Subcompartment Analysis

RWCU Line Break:

[Filter/Demineralizer Room]

In this paper, phenomena associated with a particular RWCU line break which is discussed in light of a recent River Bend Station (RBS) request to utilize the GOTHIC code for subcompartment analysis using a drop/liquid conversion model. A number of CONTAIN subcompartment calculations are presented to demonstrate the range of break room peak pressures that may be encountered with this class of subcompartment analysis based on water entrainment, de-entrainment, and slip ratios in exit pathways. Additionally, the appropriate assumptions for a conservative assessment of the RBS RWCU line break in the Filter/Demineralizer room are summarized.

Figure 7 Pressure calculations in the filter/demineralizer room for the 8 inch RWCU line break [SAR injection sources and SAR vent pathways].

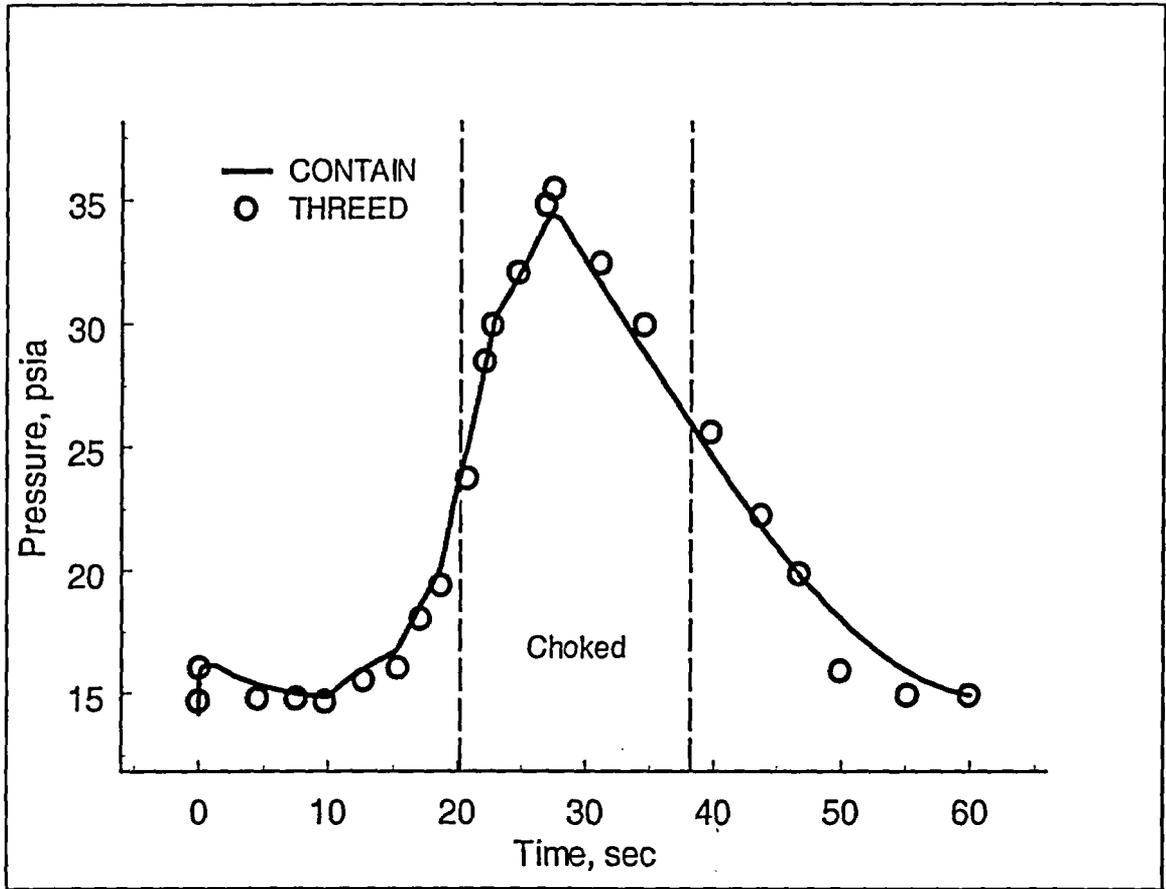
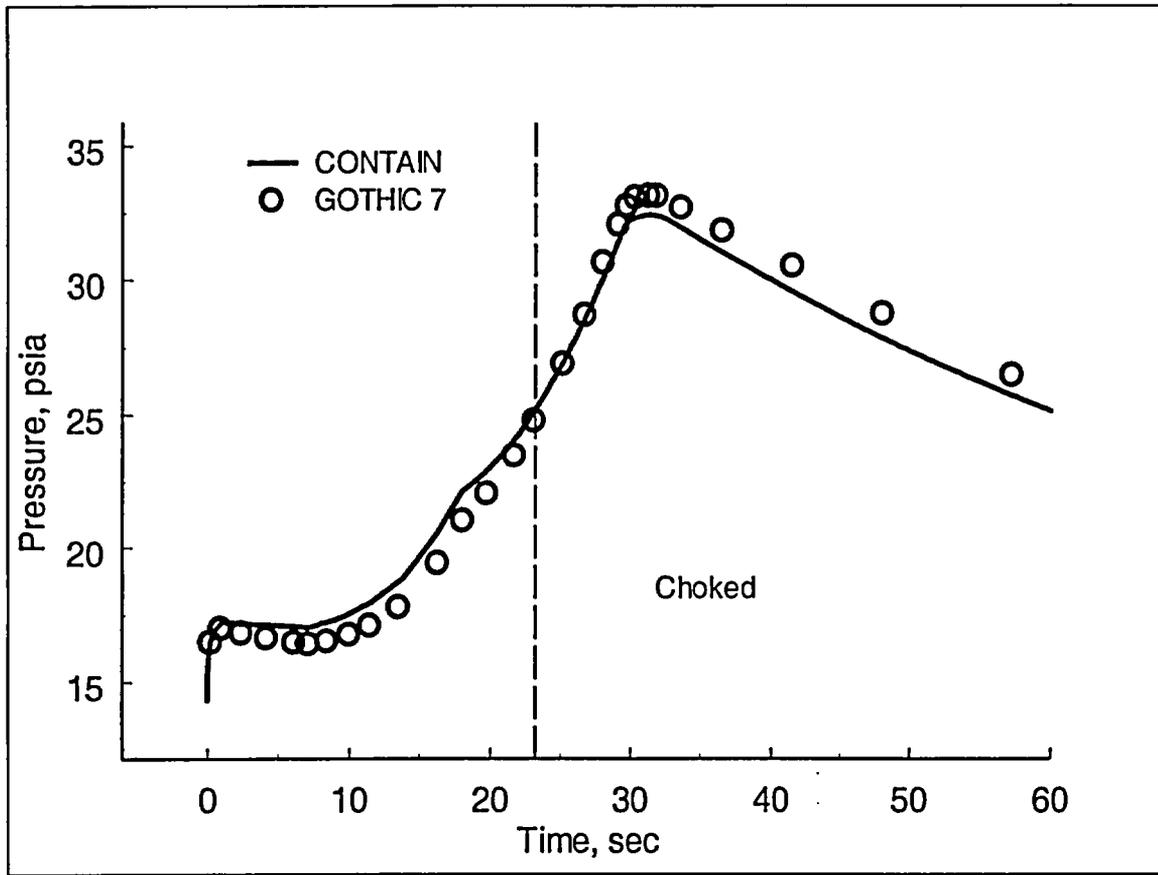
Benchmarking. Shown in Figures 7 and 8 are comparisons of the CONTAIN calculations for the RWCU line break in the Filter/Demineralizer room, with similar RBS code calculations performed with THREED (SAR) and GOTHIC 7 (new pathways and updated source), respectively. In the CONTAIN calculations, 100% entrainment of unflashed water is assumed, along with homogeneous flow through the pathways. Figure 7 shows that the CONTAIN and THREED code results are essentially identical. This confirms the original licensing basis and assumptions for entrainment and flow used in the RBS SAR. Figure 8 indicates that the CONTAIN results also compare favorably with GOTHIC calculations using updated break line sources and new vent pathways provided that the drop/liquid conversion model option is *not* used. Without the drop/liquid conversion model, the GOTHIC code appears to include models that force 1) 100% entrainment, and 2) homogeneous flow. Because the exit flows are choked in both the SAR and updated calculations (per CONTAIN result analysis), it would also appear that the critical choked modeling in all three codes, with $S=1$, are also similar. We note that the homogeneous frozen modeling (HFM) for critical choked flow in CONTAIN is scaled by input (recommended multiplier factor = 0.7) to approximate the homogeneous equilibrium model (HEM) used in both THREED and GOTHIC: the period of choking calculated by CONTAIN is shown in both Figure 7 and 8.

Figure 9 Break room pressure sensitivities for various subcooled liquid entrainment percentages for the 8 inch RWCU break in the filter/demineralizer room.

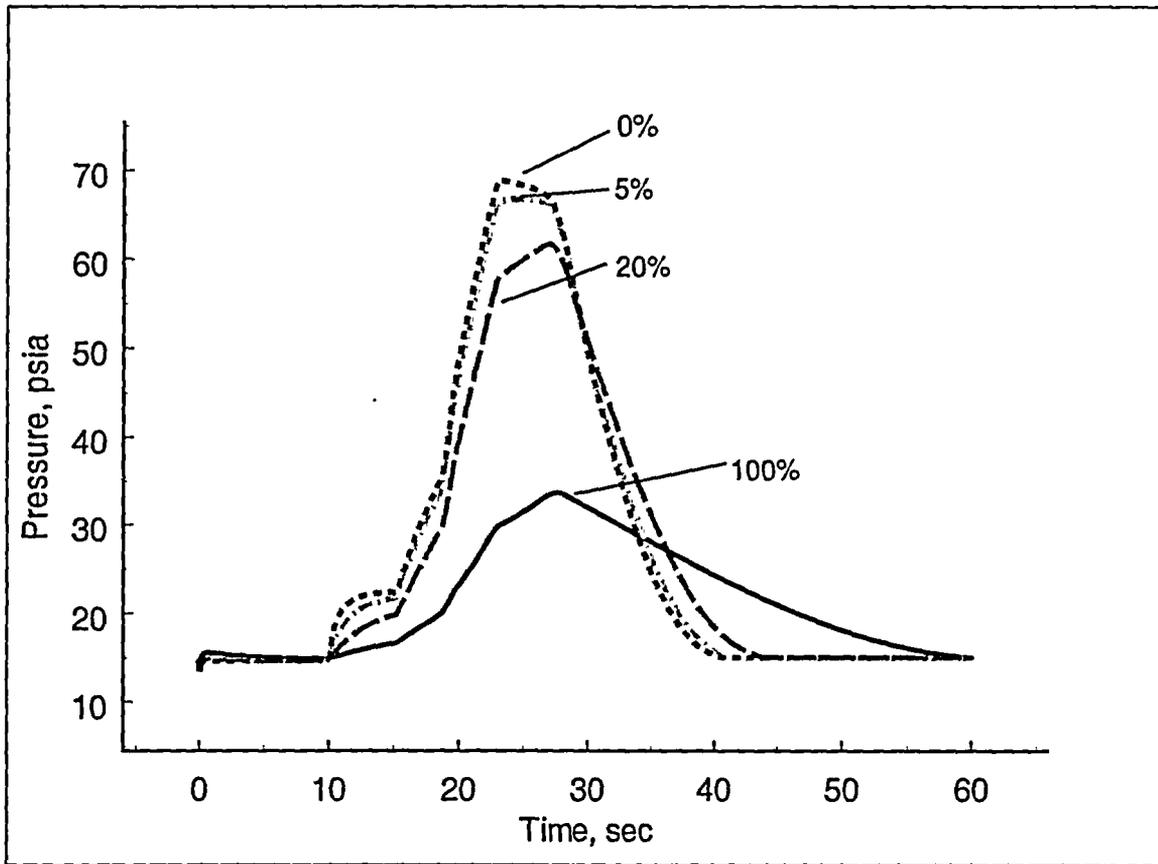
Subcooled liquid entrainment. The initial injection of subcooled liquid into the break room was assumed to have 100% water entrained into the free gas volume with no de-entrainment. Some breakup of the liquid jet could be expected due to mechanical or aerodynamic forces, but as noted above the assumption that 100% of the liquid is suspended would appear to be an overestimate, and nonconservative. Shown in Figure 9 are pressure profiles calculated assuming various entrainment amounts for the initial (10 second) injection of subcooled water. In these calculations, the liquid *flashing* jet, after

10 seconds, is assumed to be 100% entrained (as assumed in the benchmark exercise). These results from CONTAIN calculations show that peak pressure in the break room is very sensitive to the assumption of how much entrainment of the initial subcooled liquid water occurs.⁴ From the discussion concerning subcooled liquid injections, it would be reasonable to select entrainment percentages significant below 100% for this early source of water. A conservative assumption would exclude subcooled liquid water as a possible entrainment source, locating this water into the sump of the break room.

Figure 11 Sensitivity of break room pressure for 8 inch RWCU line break to de-entrainment of unflashed liquid water injected after 10 seconds.

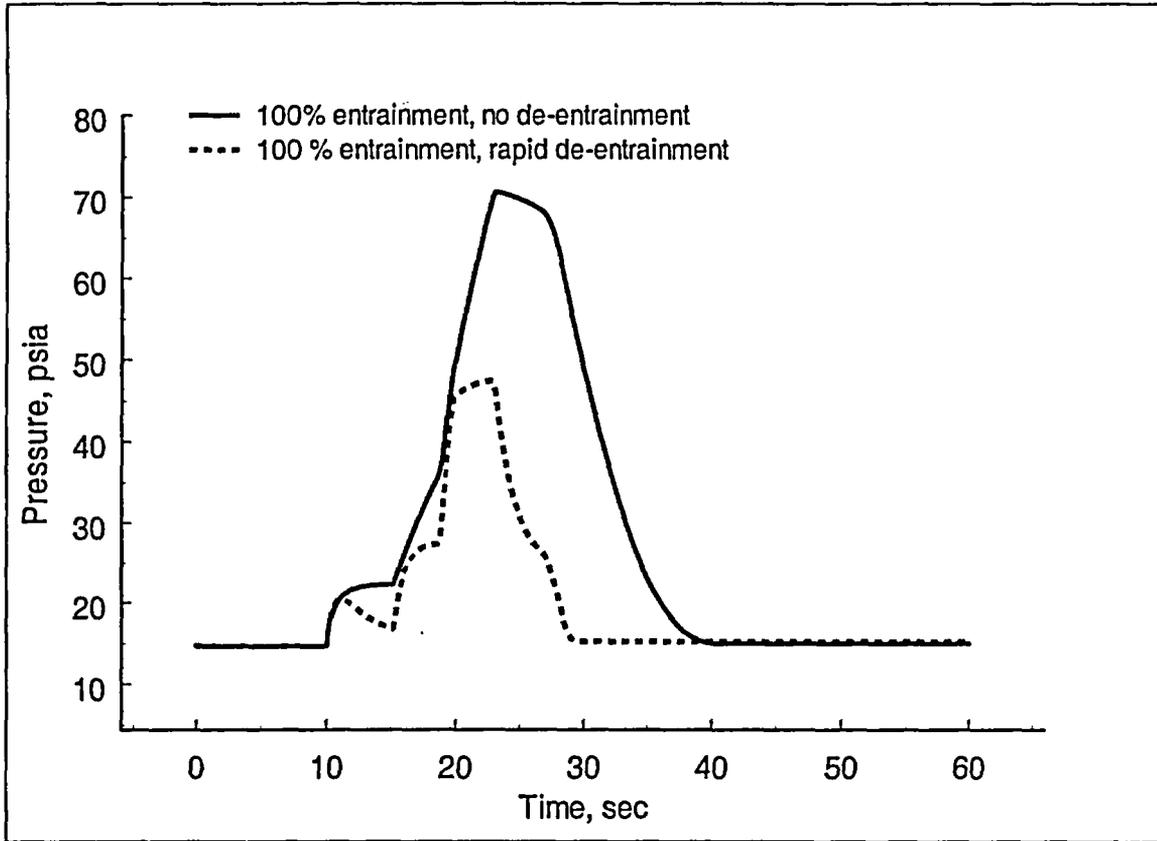
In the above flashing liquid calculations, the unflashed liquid entrained into the atmosphere is assumed to remain suspended throughout the accident. Of course some liquid will be de-entrained by some of the processes listed in Table 1. Shown in Figure 11 is a sensitivity calculation assuming an initial 100% entrainment of unflashed liquid water with subsequent rapid dropout (removal of liquid water at end of timestep). The gas/vapor quality in the break room is shown in Figure 12. The increased quality for the case with essentially an infinite deposition rate effectively increases the gas/steam mass flux through the exit pathway according to $G_v = X_{st} * G_m$. The low quality for the ~ zero deposition rate significantly reduces the gas/steam flow and therefore increases the peak pressure calculated for the break room.

Figure 13 Sensitivity of break room pressure for 8 inch RWCU line break to slip ratios. The solid line represent the case with homogeneous flow, $S=1$. The dash-dot line corresponds to a simulation of near infinite slip ratio.

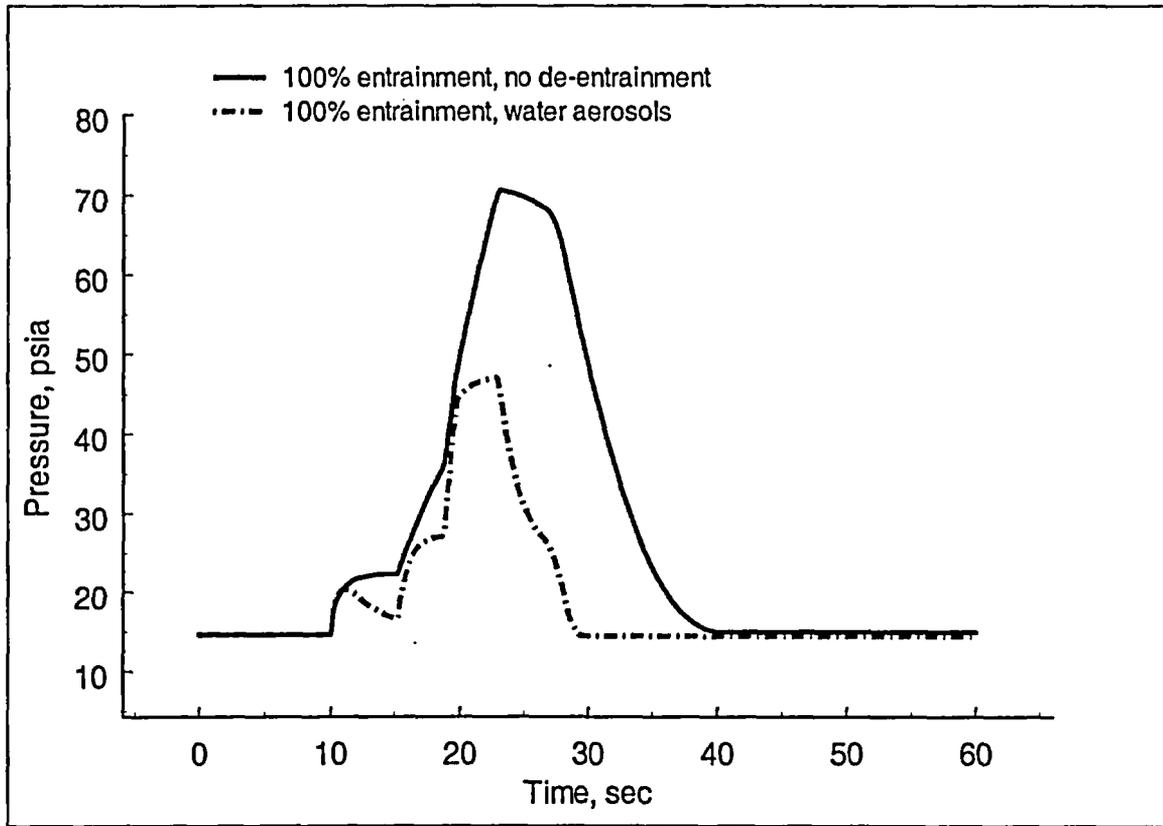
suspended liquid aerosol in the fluid density, an infinite slip ratio is simulated. Shown in Figure 13 is the pressure profile comparisons for 100% entrainment of unflashed liquid with liquid included in the fluid density ($G_v = X_{st} * G_m$), and the case with liquid excluded ($G_v = G_m$). The break room qualities, representing suspended water, are shown in Figure 14 (note: only for the case labeled "liquid suspension" is the quality factored into the calculation of gas/steam flow). Both methods have the suspended water in thermal equilibrium with the gas/steam mixture. It is interesting to note that the pressure profiles for aerosol suspension and the case with rapid dropout are essentially identical. These comparisons indicate that whether simulating rapid de-entrainment or ~ infinite slip ratio the cases result in similar break room pressures.⁵

Figure 15 Sensitivity of pressure profiles to exit pathway area for the filter/demineralizer during an 8 inch RWCU line break (SAR sources and pathways).

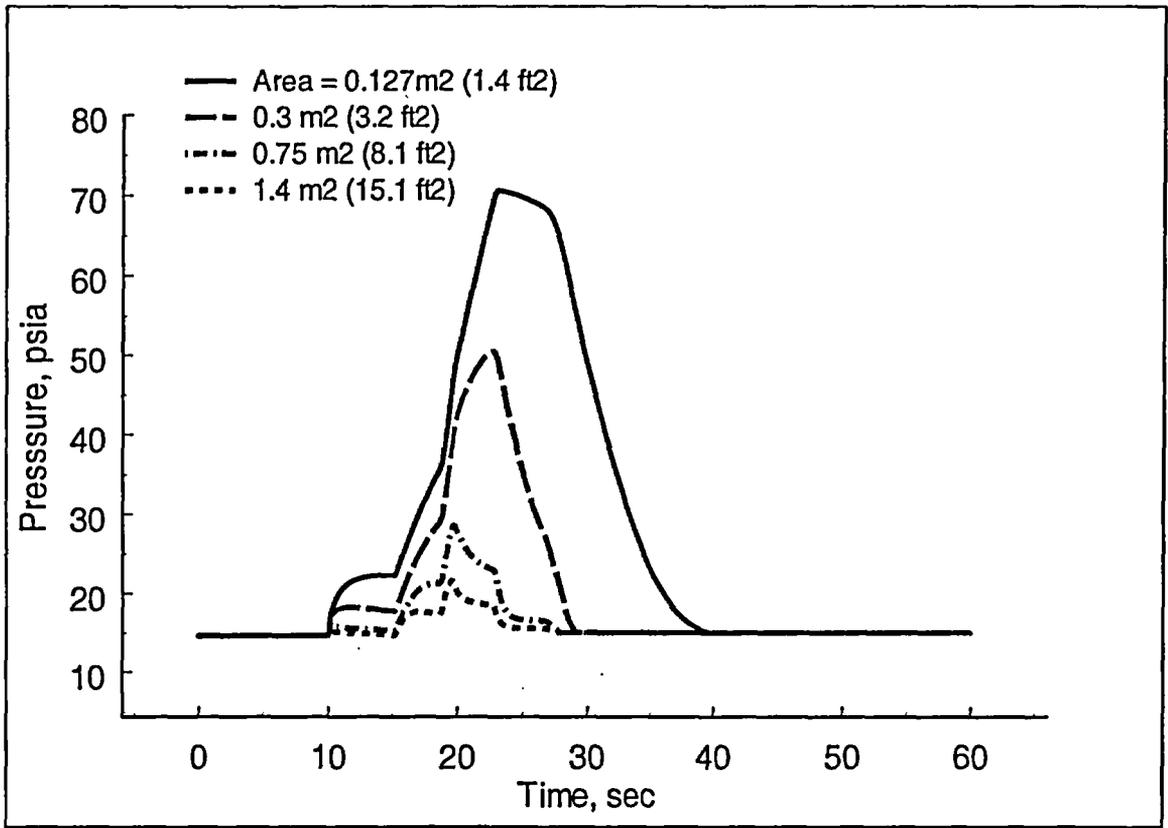
Vent pathway flows. The exit pathway area for the Filter/Demineralizer room, referenced in the RBS SAR calculations, is 0.127 m² (1.4 ft²). This vent area is quite small, and notably smaller than similar vents for Filter/Demineralizer rooms in some other Mark III containments (~ 1.4 m² or 15.1 ft²). Shown in Figure 15 is a comparison of pressure profiles for the 8 inch RWCU line break for various exit vent areas. As indicated in the figure, very modest peak pressures are shown for vent areas that approach the 1.4 m² vent exit area. Figure 16 shows the quality profiles in the break room calculated for these vent areas. Note that these calculations are performed with the subcooled liquid directed to the sump and 100% entrainment of unflashed liquid water with no de-entrainment in the break room. The vent flow is modeled as homogeneous flow.
